Subject: PEFS F3 / F3N LOP Manual Actuator Improvements

Product: PEFS F3/F3N systems

Parts: 47130 and 47131 LOP Actuators

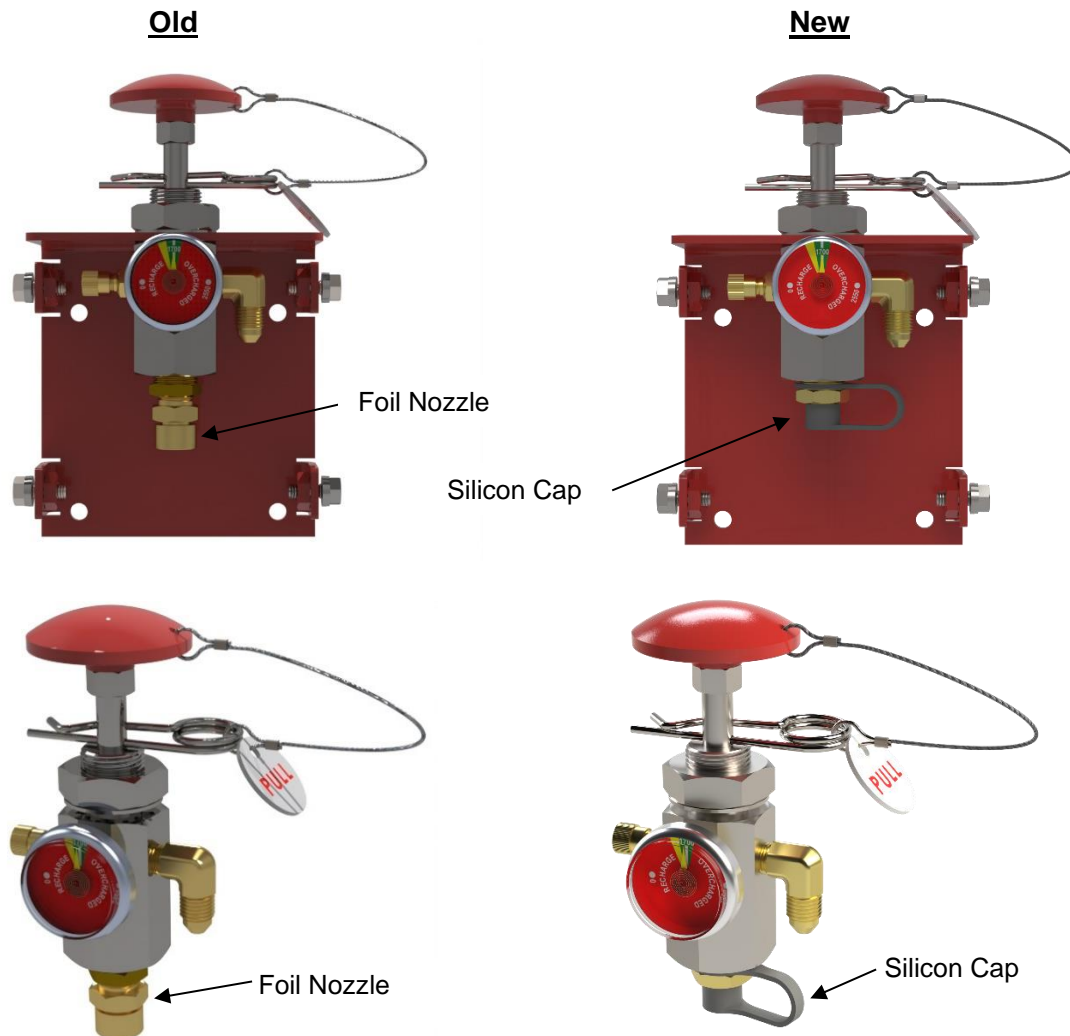
The outlet of the PEFS F3 and F3N LOP manual actuators has been changed from using a foil rupture nozzle to an outlet fitted with a high temperature silicon blow-off cap.

This change has been implemented for the following improvements:

1. There is no longer any need to replace the outlet nozzle after every time the manual actuator is used to activate the PEFS system. The new silicon blow-off cap can be easily re-fitted to the actuator outlet.
2. Prevents the wrong foil rupture nozzles being fitted to the actuator when being replaced.
3. The outlet has a larger orifice to improve the release of pressure

Infield Action:

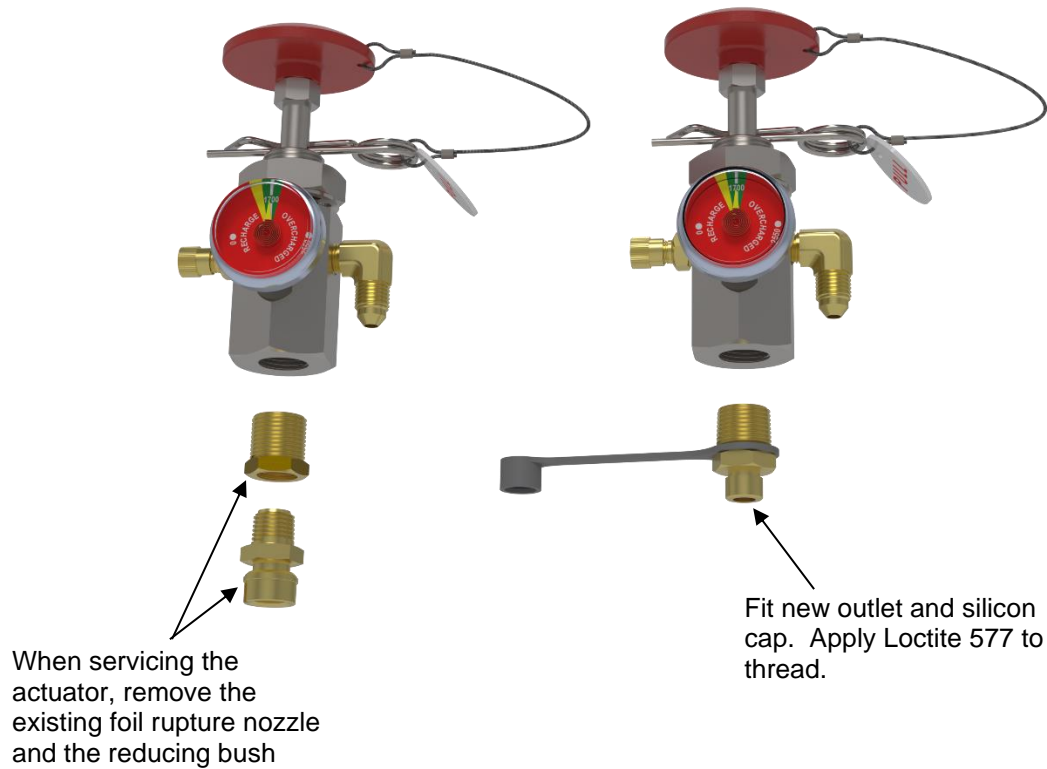
The new silicon caps should be replaced annually in line with the annual service of the actuator. The LOP actuator service kit 28038 will now include the new actuator outlet and the silicon cap instead of the foil rupture nozzle to allow the older LOP actuators to be upgraded when they are scheduled for their next annual service.
